Brent Spence Bridge Corridor Project Aesthetic Design Committee Meeting Summary (KY) June 28, 2022

Covington Aesthetic Sub-Committee Meeting No.1 June 28, 2022 – (KYTC D-6 office, 3-5 pm)

BRENT SPENCE BRIDGE CORRIDOR PHASES I AND II PID Nos. 113361 & 114151

City of Cincinnati Department of Transportation and Engineering (DOTE) Follow-Up Aesthetic Design Committee Comments

DESIGN OVERVIEW Sampled Cross-Section Illustrations

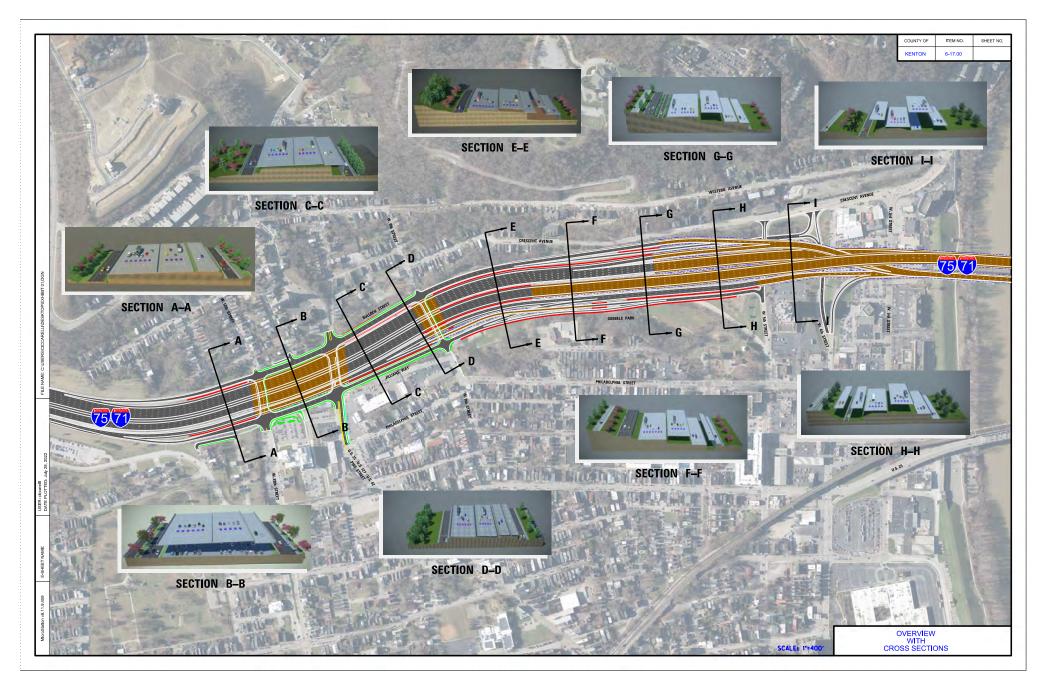
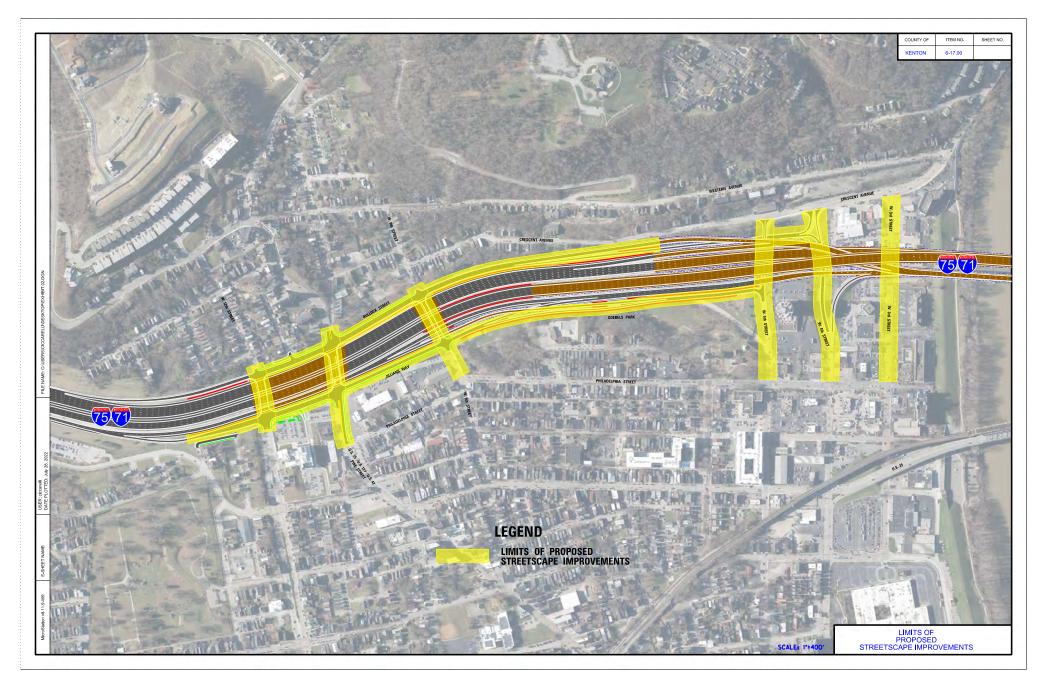
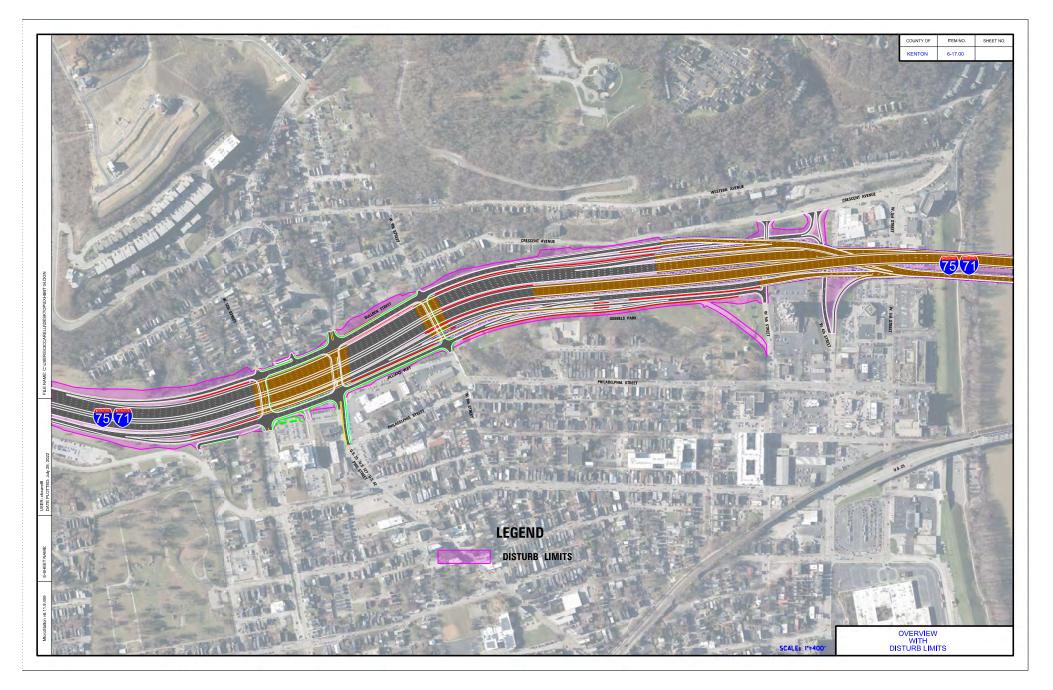
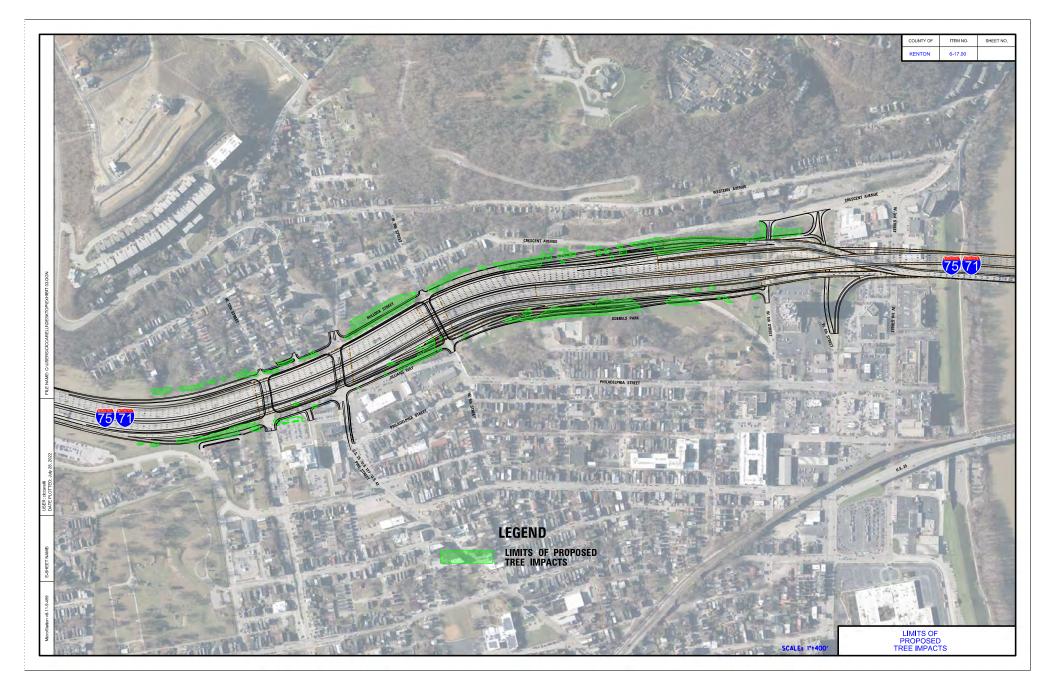
- a) Design Overview
 - Sampled cross-section illustrations provide examples of how landscaping can be provided along both sides, but ultimately these buffer plantings are subject to design preferences of the advisory group.
